Supplemental Information for 021-511 or 120694 Angle Drive (Speedometer Cable to Gearbox) Austin Healey BN4-BJ8, MGB 63 on, TR'S 63 on

TECHNICAL SERVICE BULLETIN

Re: Right Angled Speedometer Adaptor Failures

WASHER 3H 550

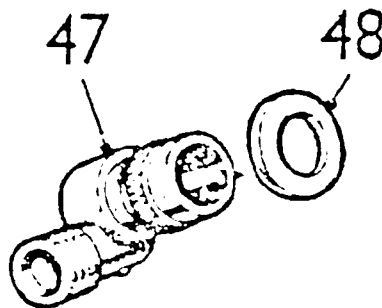
Repeated failures of the above have, in many instances, been caused by Washer-Adaptor to gearbox Part Number 3H 550 not being fitted when a new right angled drive adaptor is installed.

This causes an excessive end load and premature failure of the right angled drive pinion.

IMPORTANT! When fitting the angle drive, fit a 324-720 or 3H550 washer as shown on the next page.
